April 12, 2021

Ms. Shannon Ames, Executive Director
Low Impact Hydropower Institute
329 Massachusetts Avenue, Suite 2
Lexington, MA 02420

Subject: Medway, Orono, Stillwater Projects

Figure 4-1: Total flow and water temperature as recorded at Medway for the period October 15 to November 15, 2020.

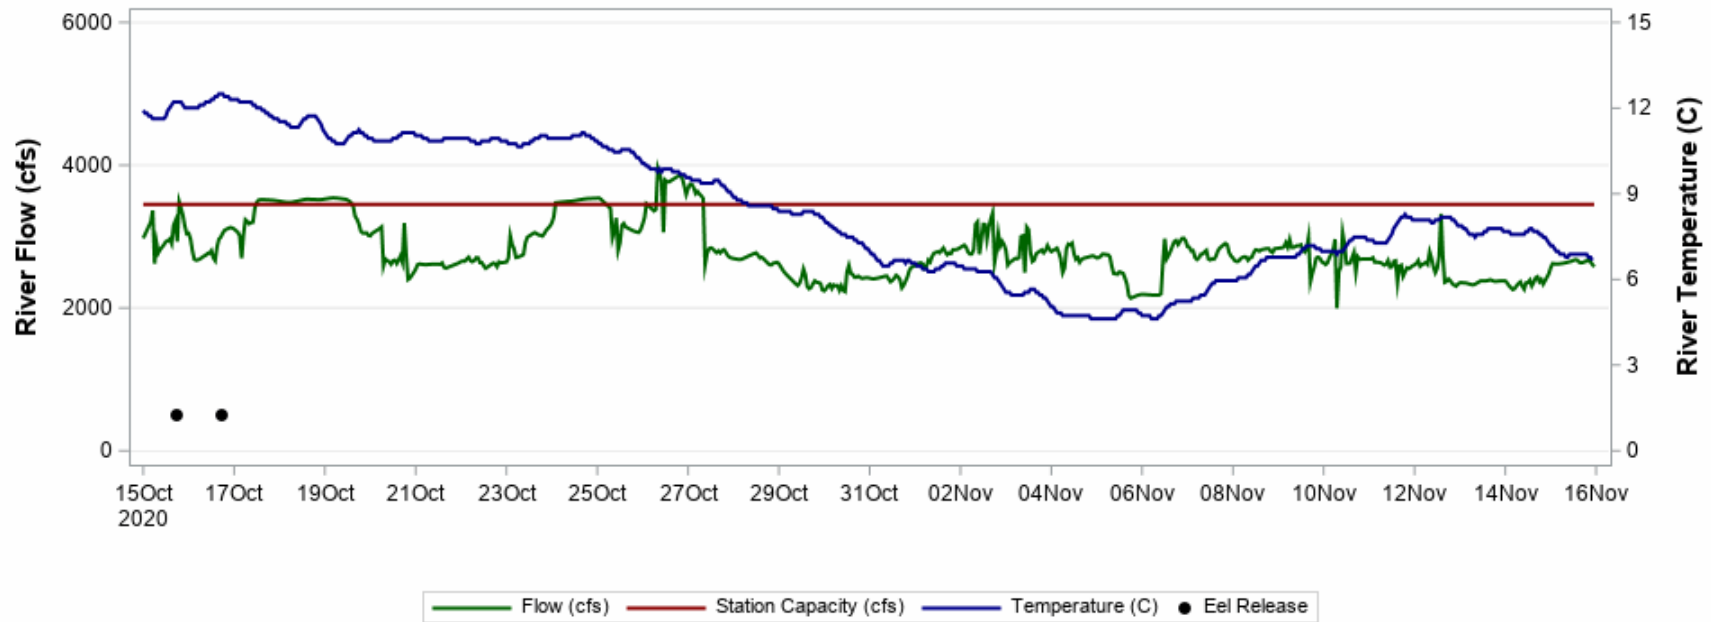
Question 1: *Please include a line showing the Medway station hydraulic capacity in Figure 4-1.*

Response 1: The Medway powerhouse contains a total of five vertical Francis turbines, each with a capacity discharge of 690 cfs. A reference line for the station capacity (3,450 cfs) has been added to Figure 4-1.
